ADDENDUM #3

Reference: Noorda Black Box Theater Addition and Remodel
Utah Valley University – Orem, Utah
DFCM Project No. 08017790

ADDENDUM - 3

Project: UVU Noorda Theater
DFCM Project Number: 08217790
Axis Project Number: 0804
To: Mike Ambre
From: Axis Architects
Date: August 4, 2008

MP102

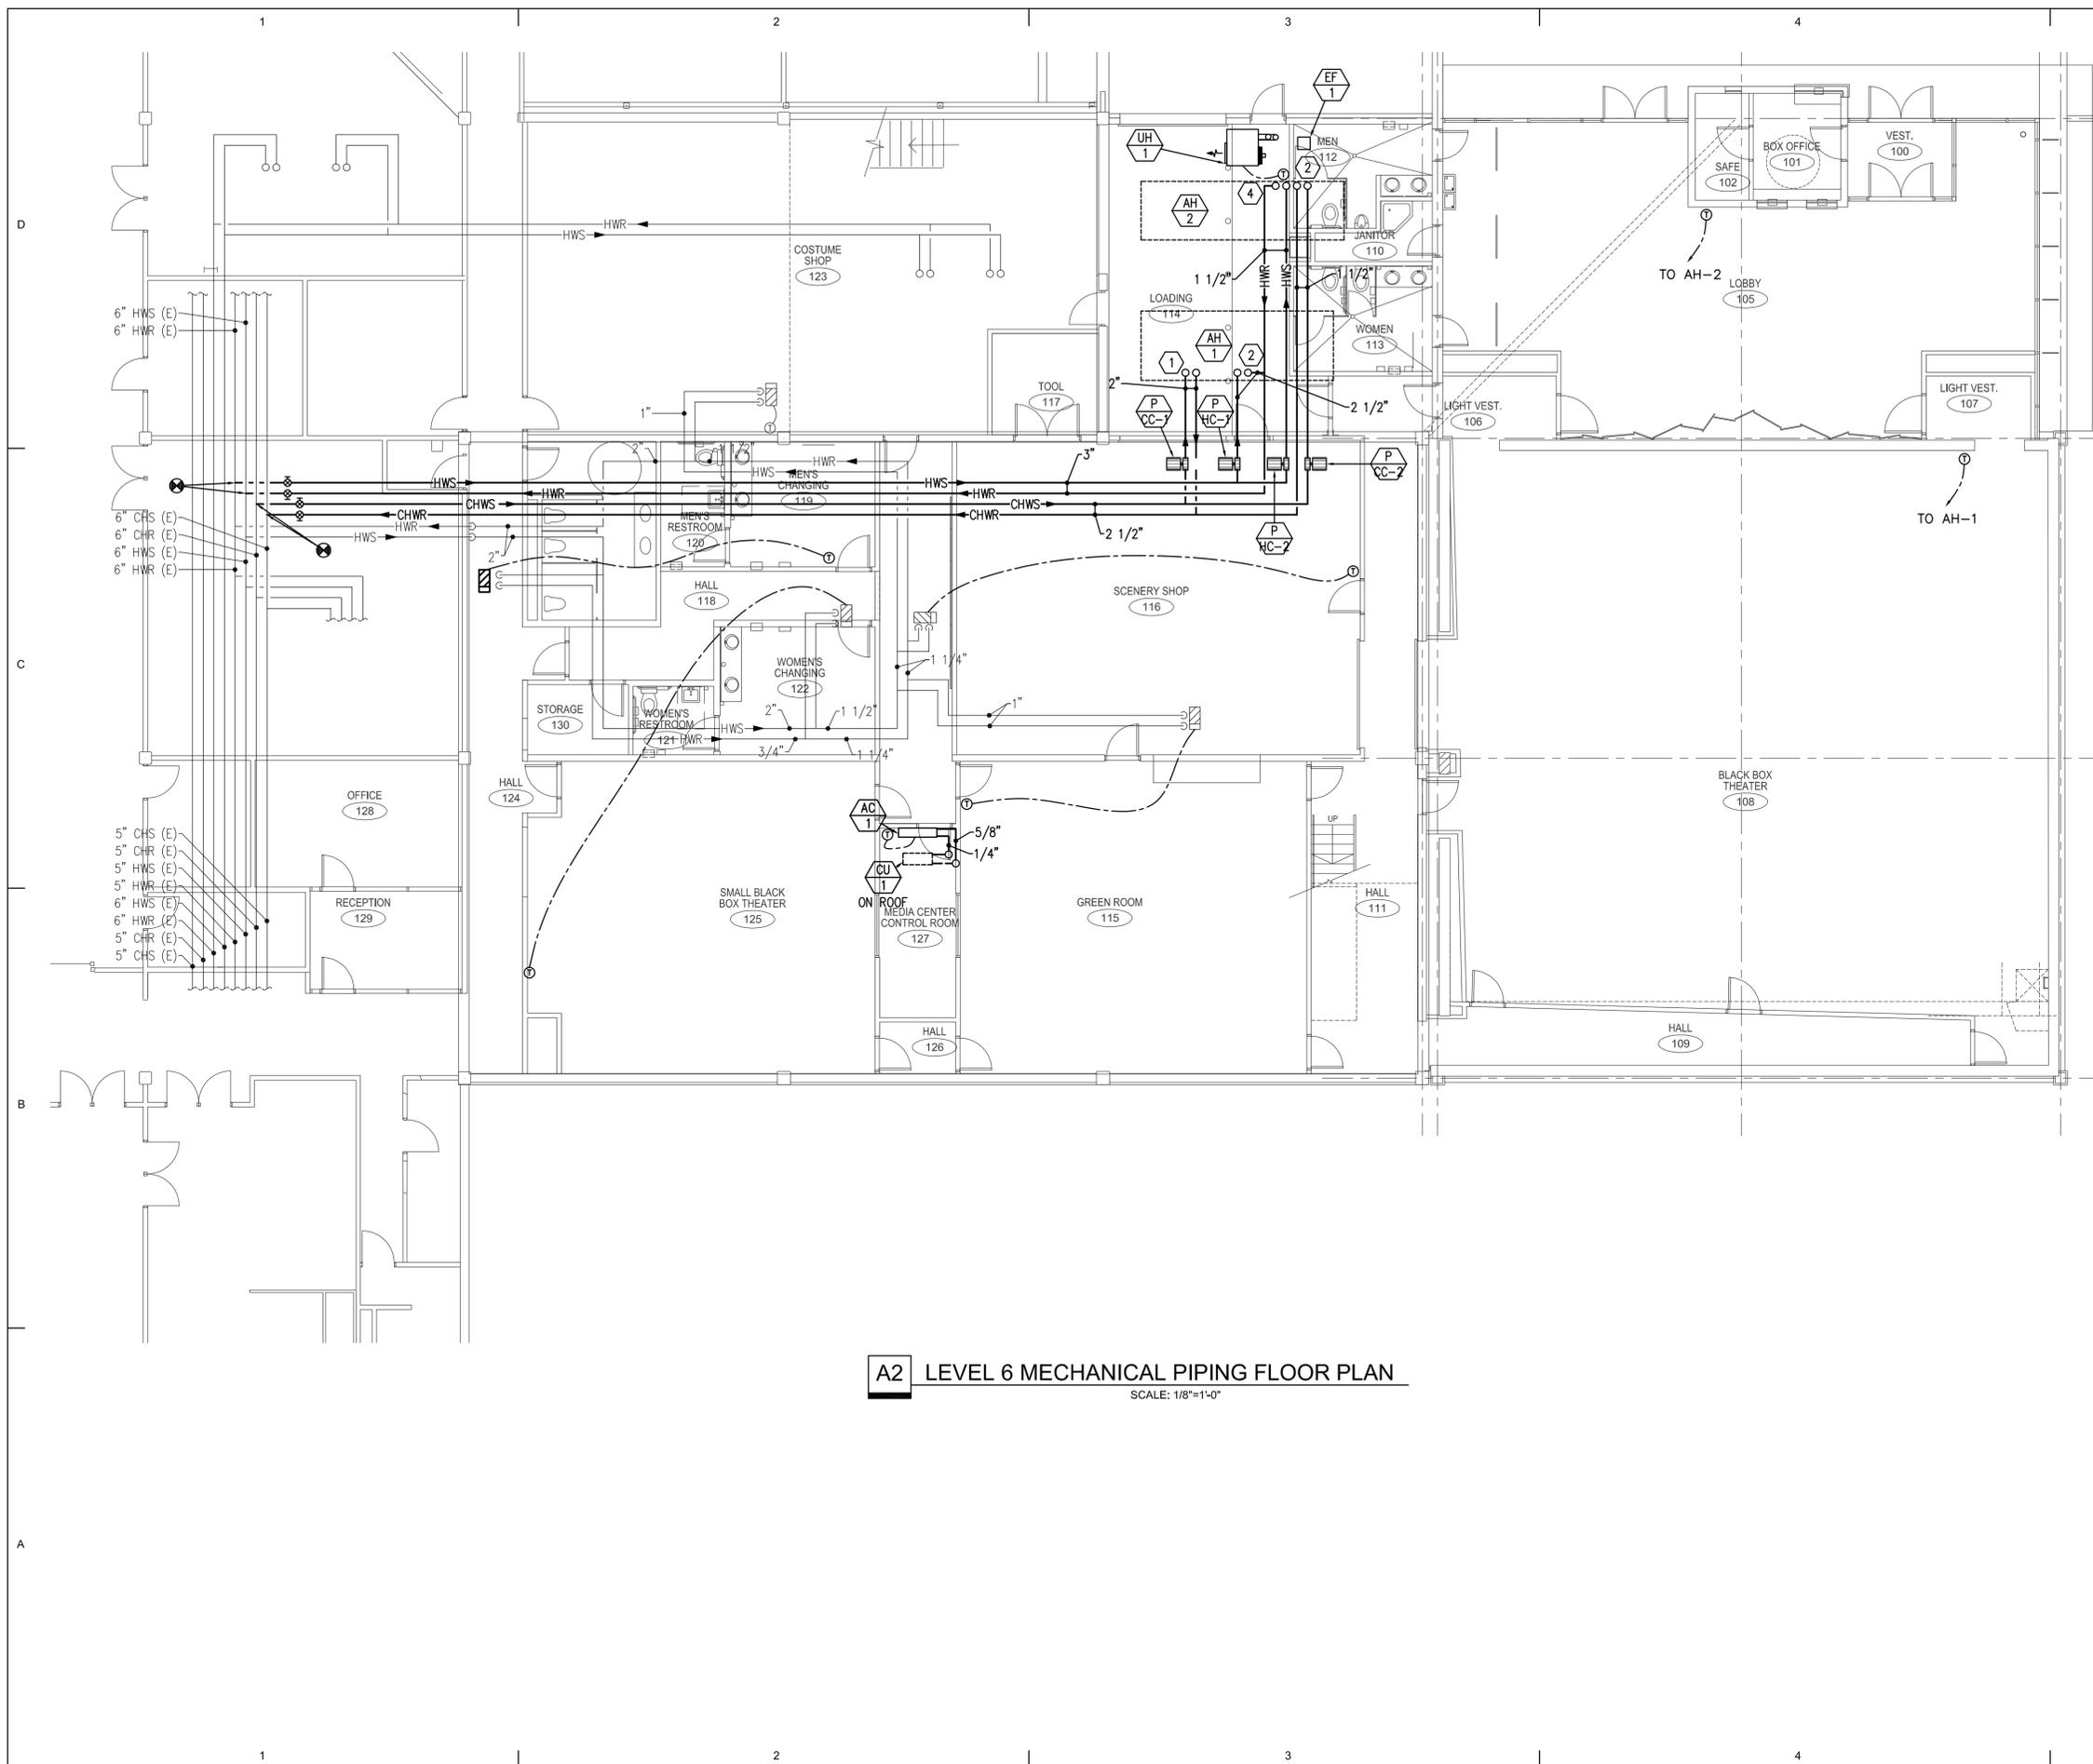
Mechanical: See the Attached Drawing Sheet MP102; refer to Architectural Addendum #1 (DFCM Addendum #2) which indicates this Drawing Sheet to be added.
